August 29, 1977
Re: Indian Point Unit No. 3
Docket No. 50-286

As requested by your letter of June 3, 1977, we have compared the current design of the Indian Point Unit No. 3 emergency power system with the staff positions stated in the enclosure to your letter. A detailed analysis which shows our facility design has equivalent capabilities and protective features to those stated in staff positions 1 and 2 is attached.

INDIAN POINT NO. 3

480V Safeguard buses #2A & #3A are normally supplied from the generator and in turn together supply a 50% train of safety related equipment (various offsite power source connections can be seen on the attached sketch SK-6868-1).

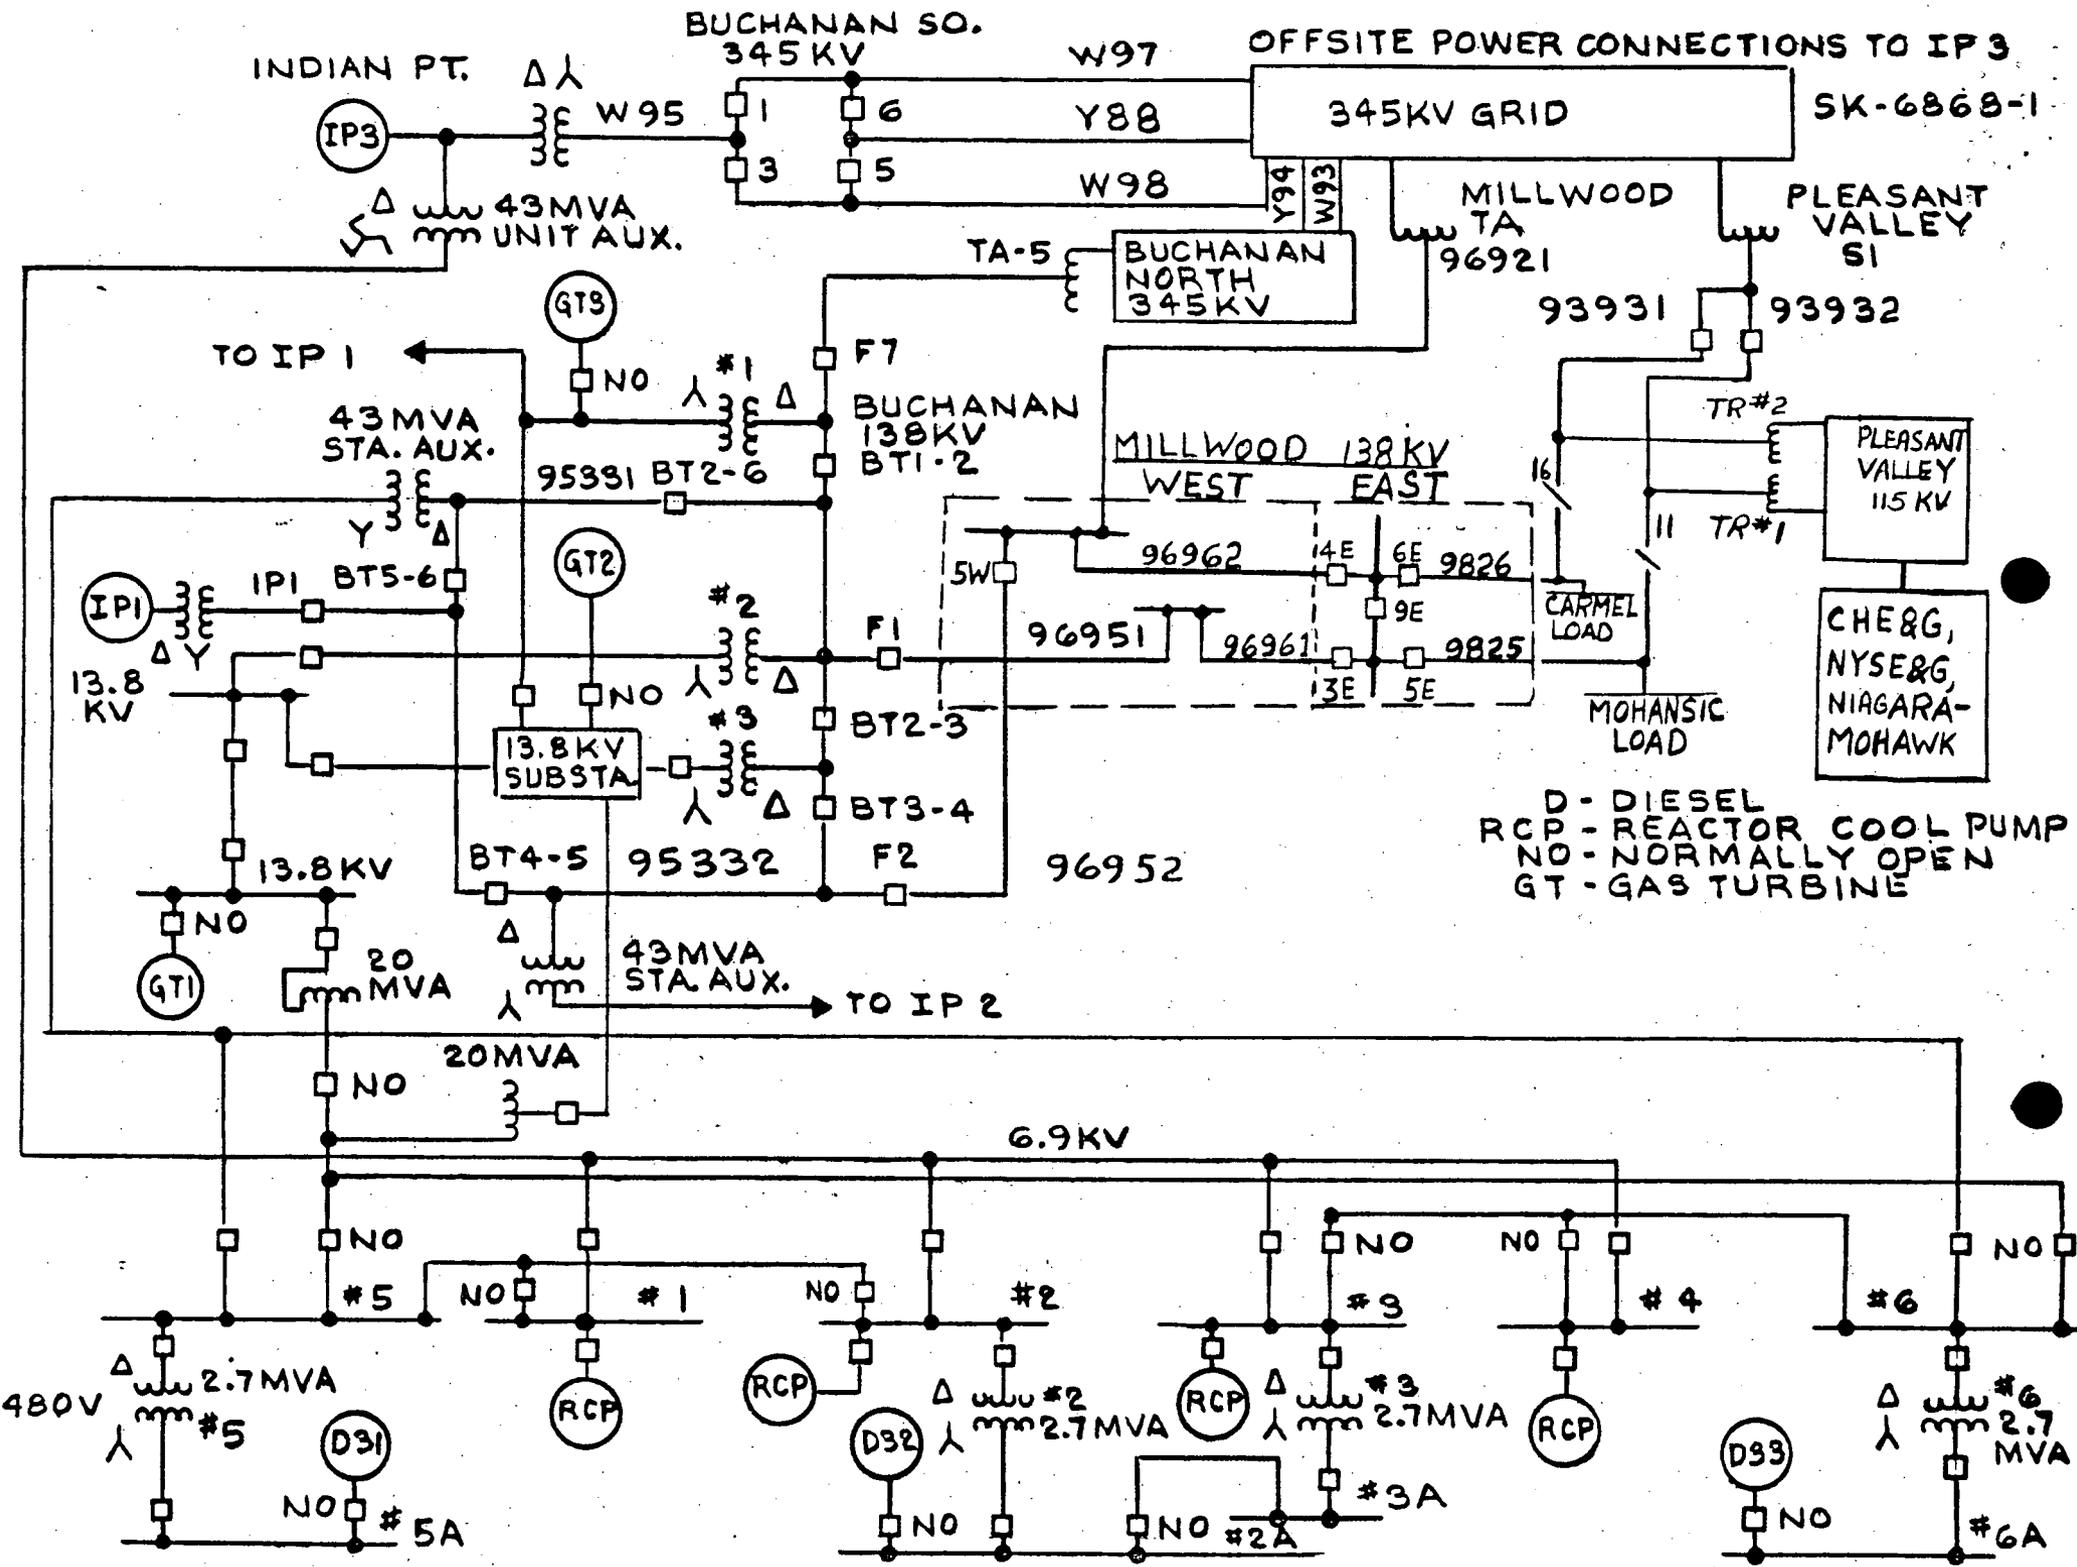
POSITION 1 - Second Level of Under-or-Over Voltage Protection with a Time Delay.

2. During normal plant operation, 480V safeguard buses #5A & #6A are supplied from the 138KV grid and in turn each supplies a 50% train of safety related equipment.

The worst generator terminal voltage degradation that will not cause a unit trip would result from large reactive power flow into the generator due to abnormally low generator excitation, such that conditions are just outside the loss-of-field relay trip characteristic. This condition will result in low voltage on the Buchanan 345KV S/S South bus (97% or 336KV). Buses #2A & #3A will be at 94%V or higher and buses #5A & #6A will be virtually normal.

The worst 138KV degradation would result if Buchanan 345/138KV transformer TA5 is lost coincident with loss of 138KV feeder 96962 and associated Millwood 345/138KV transformer TA. During this contingency the Buchanan 138KV offsite power supply bus will be supplied only from Pleasant Valley 345KV S/S (S1 transformer) and Pleasant Valley 115KV S/S (transformers 1 & 2) through 138KV feeder 96951.

The Buchanan S/S 345KV South bus voltage is calculated at 102% immediately after the contingency, but generator voltage regulator response will immediately restore voltage to normal. Under this condition the voltage on buses #2A & #3A are normal and buses #5A & #6A will be at 90% or higher.
